Notice of Allowability

10/522,481

CHA ET AL.

FIG.6

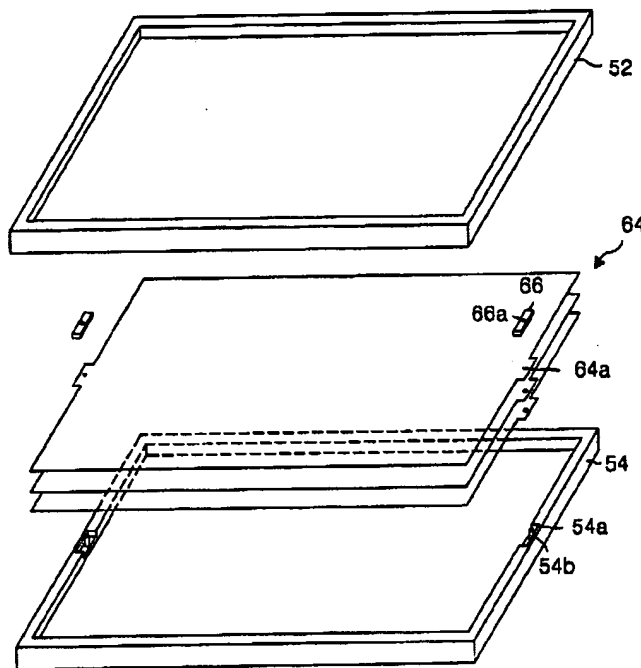
The prior art made of record and not relied upon is considered pertinent to applicant's disclosure. Kim et al (2002/0024623) teaches the use of an elastic silicon

pad (66) for preventing damage and wrinkling to optical sheets (64) caused by motion or vibration to a liquid crystal display but does not teach the elastic member (66) also being adhesive, as claimed by applicant. See paragraphs [0026], [0027] for the teaching of the elastic member (66) being secured in place by the pin (54b) through hole (66a) and by pressure of the panel guide (52)

and main frame (54). Kim et al (2002/0024623), alone or in combination with the other cited prior art, does not teach or suggest all of the limitations of the amended independent claims 1 and 9.

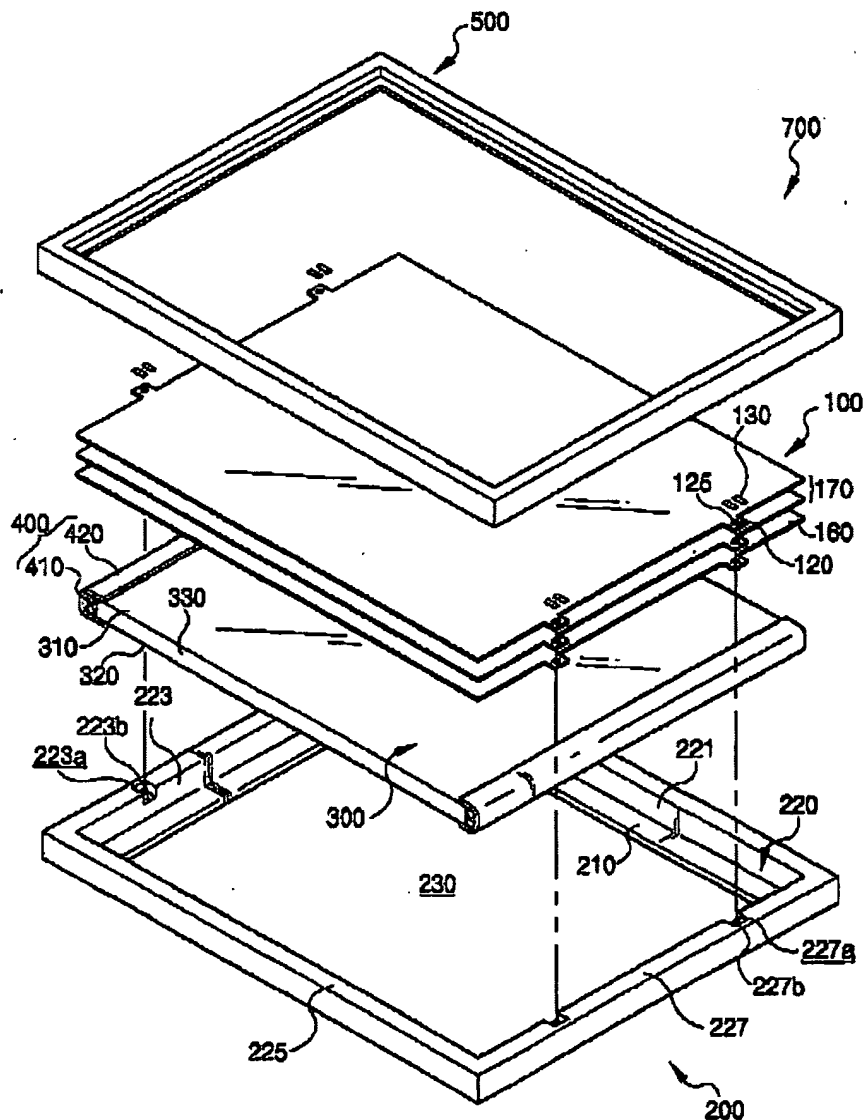
Claims 1-12 are allowed, because the cited prior art, alone or in combination, do not teach or fairly suggest a backlight assembly (700) comprising a first receiving container (200) having a bottom surface and a sidewall (223,227) extended from edge of the bottom surface (210) so as to provide a receiving space (230);

an optical module (400) including a lamp (410) for generating a first light and a first optical member (420) for generating a second light having a brightness more uniform than that of the first light;

a second optical member (100) including a body (110) for generating a third light by controlling optical characteristics of the second light and at least one fixing portion (120) protruded from edges of the body (110) toward the first receiving container (200) and coupled to the sidewall (223,227);

a second receiving container (500) combined with the sidewall (223,227) of the first receiving container (200) for covering the fixing portion (120);

and an elastic adhesive member (130) disposed between the fixing portion (120) of the second optical member (100) and the second receiving container (500), the elastic adhesive member (130) absorbing impact applied from an exterior and being expanded or contracted by a predetermined length corresponding to an expansion of the second optical member (100) to prevent a wrinkle of the second optical member (100). Further, the cited prior art do not disclose or fairly suggest a liquid crystal display panel (1000) comprising the features of the claimed backlight assembly (700) and a liquid crystal display panel (800) disposed on the second optical member (100), for changing the third light emitted from the second optical member (100) into light having image information; and a chassis (900) for fixing the liquid crystal display panel (800).
